CITY OF KEY WEST RESPONSES TO AGENCY COMMENTS ON KEY WEST CHAPTER 288
MILITARY BASE REUSE PLAN WITH ATTACHMENTS NAS KEY WEST FL
9/8/1999
BERMELLO, AJAMIL AND PARTNERS

KEY WEST CHAPTER 288 MILITARY BASE REUSE PLAN

Response to Agency Comments
September 8, 1999

**Concept Plan and
Proposed Land Use Classification**

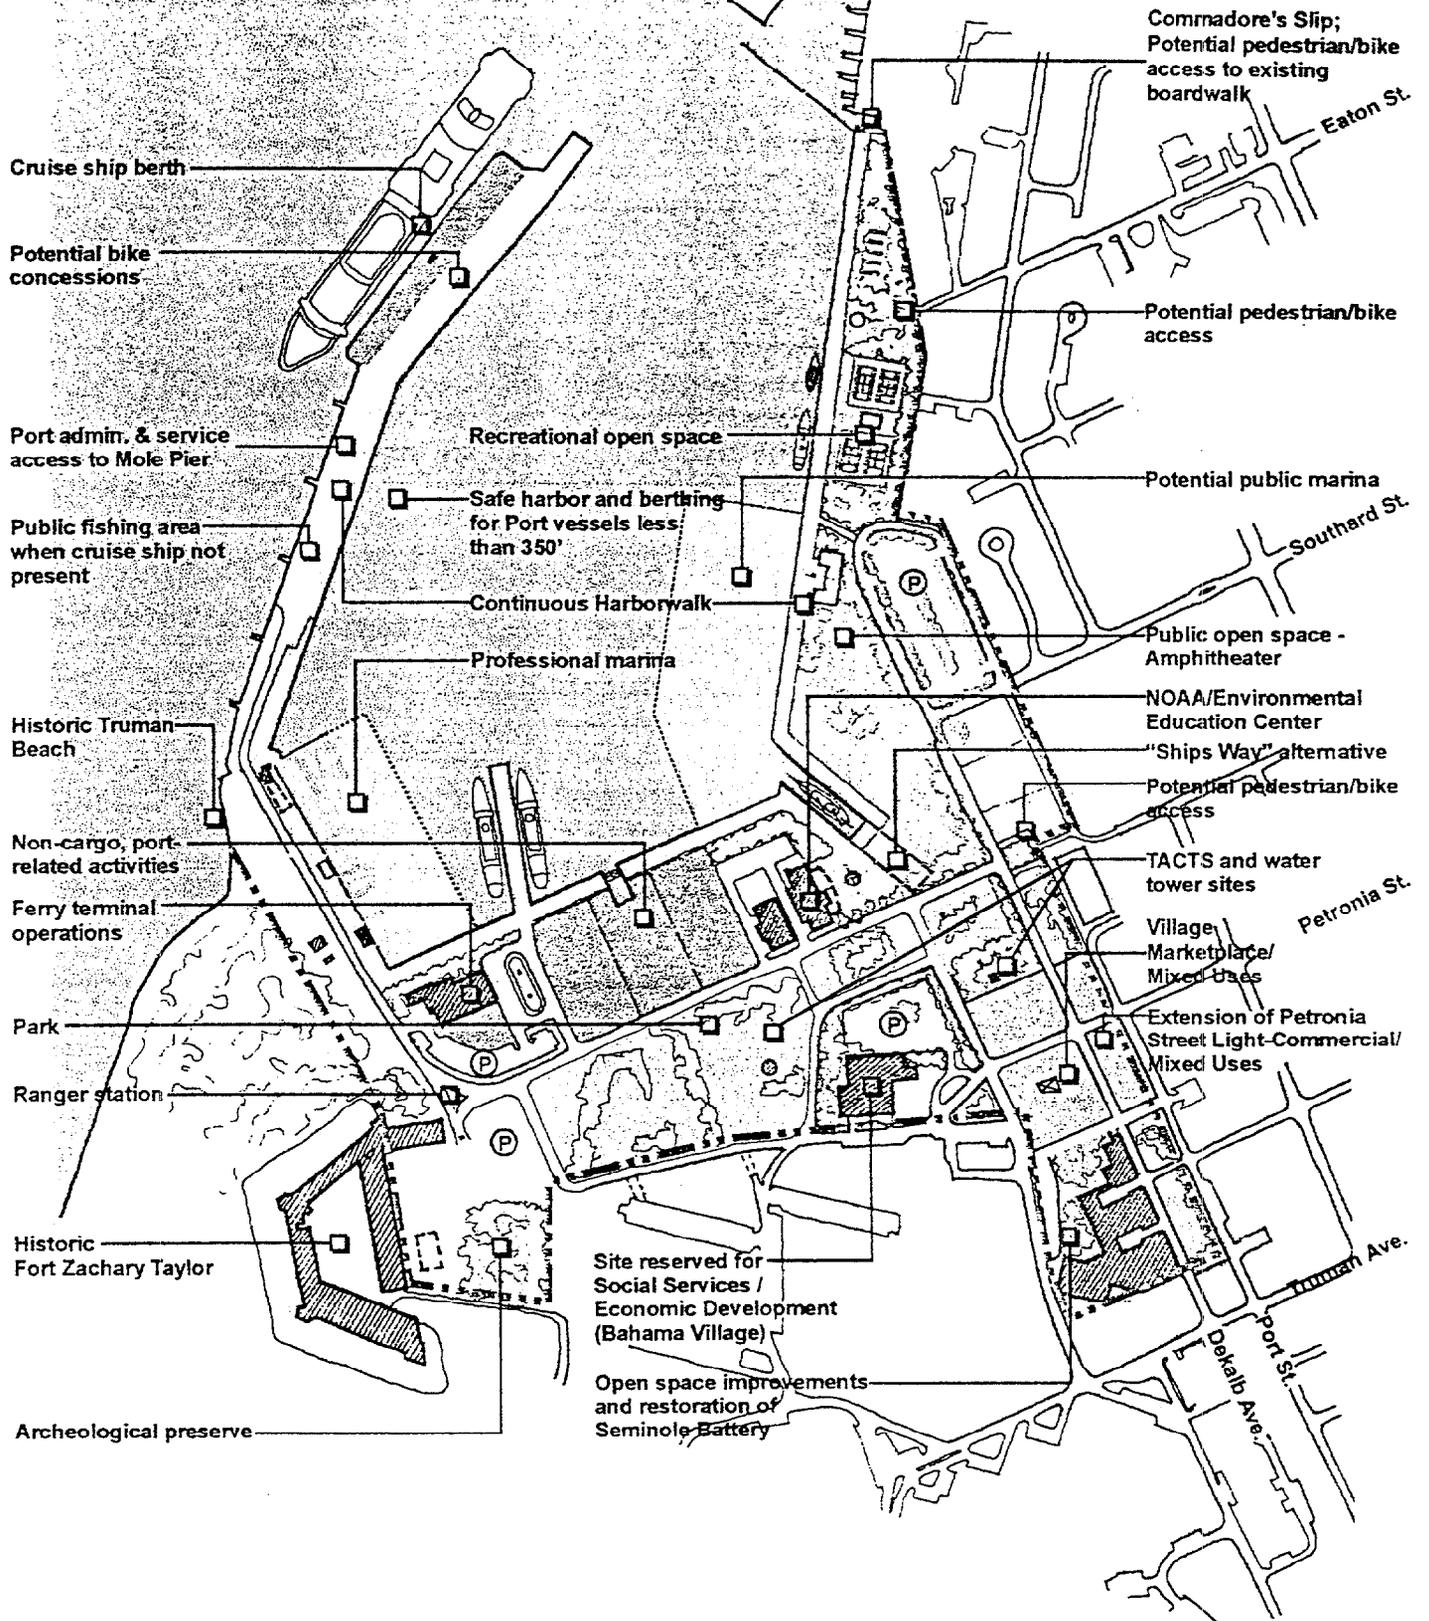
- 1. FLUM Amendment - The FLUM designations should include maximum percentages for the uses in order to provide assurances that the site will develop as intended. The scale of the proposed development is of enormous magnitude for Key West, given the scale of the community. Based on the assumed scenario, the project would be a DRI under the multi use thresholds with commercial at 75% and office at 100%. Given the magnitude, some controls are needed to mitigate impacts to the extent possible. Further, as discussed in the following sections, staff recommends that reduction in the amount of commercial development should be considered to ensure consistency with transportation, public facility, affordable housing and community character needs and related constraints.**

On January 12, 1999 the City Commission adopted Resolution 99-34 expressing a strong preference that the area of the Truman Waterfront parcel designated HNC-2 be developed as parks and as active and passive recreation. Subsequently, approximately 5.6 acres of land located south of Dekalb Street extending from Bahama Village to Fort Zachary Taylor has been redesignated from HNC-2 to HPS-1. See Attachment DCA-1 --- Truman Waterfront Parcel Concept Plan and Truman Waterfront Parcel Proposed Land Use Classification.

The revised plan also recognizes that Mole Pier has been designated as a Coastal High Hazard Area and, therefore, development in this area may be limited. As shown in the table below, these changes create an approximately 50 percent decrease in residential, office, retail, and industrial development.

**Figure III.B.6
TRUMAN WATERFRONT PARCEL CONCEPT PLAN
KEY WEST MILITARY BASE REUSE PLAN**

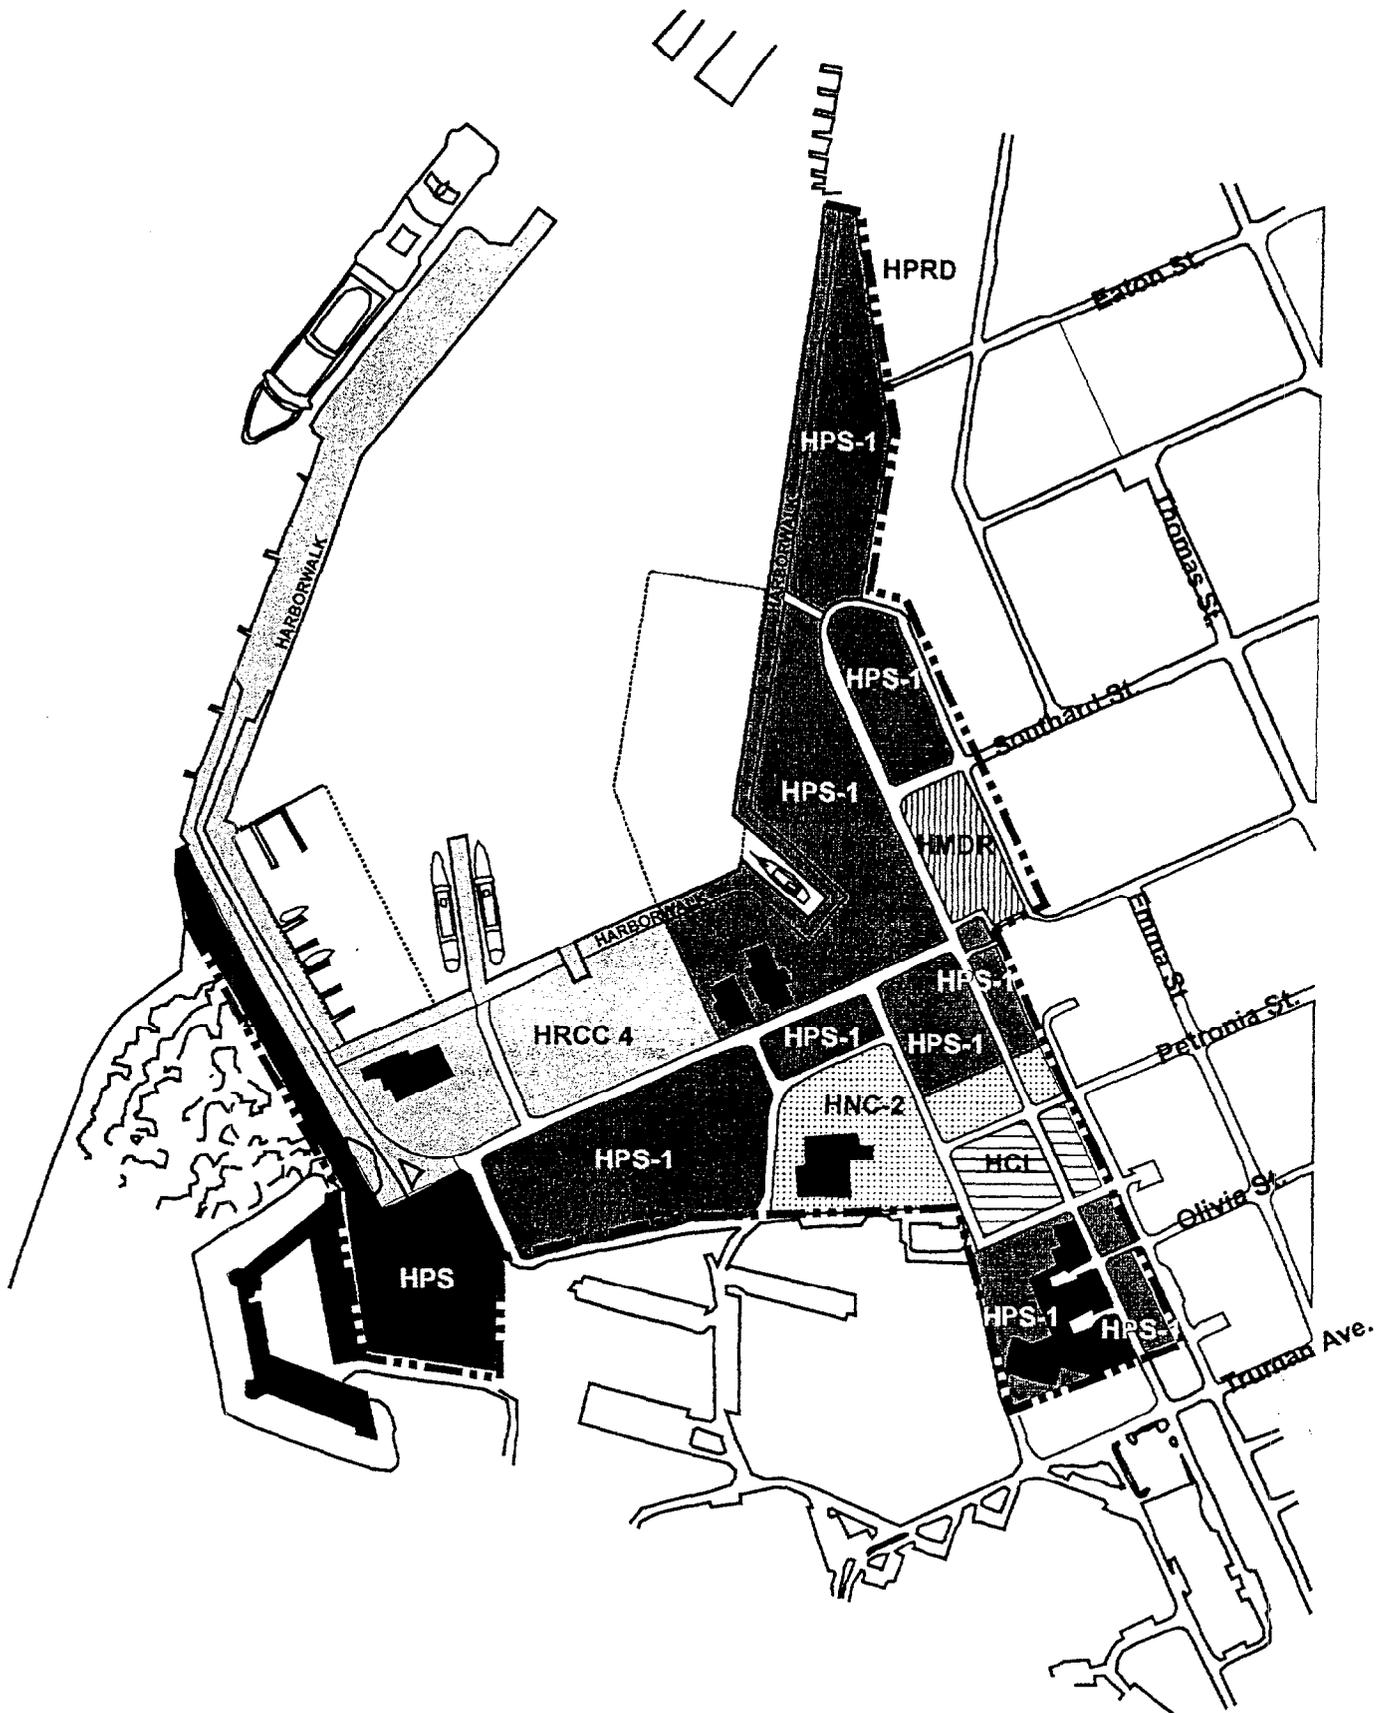
5. **The Final Conceptual Plans for reuse proposes berthing for cruise ships along the outer Mole Pier. Since cruise ships are currently berthing along the outer mole, the primary cruise ship berth is not in question. However, the addition of a secondary cruise ship berth may have significant impacts. The area proposed for the secondary cruise ship berth is not of adequate depth and would require dredging. The added ship activity could also increase water turbidity, thus decreasing overall water quality of the area. This proposed activity should undergo further review to determine ways in which adverse impacts may be minimized.**

The second cruise ship berth was eliminated by the City Commission and was not included in the draft Chapter 288 Plan.

NOTE: Potential Second Cruise Berth was Removed by the City Commission on January 12, 1999
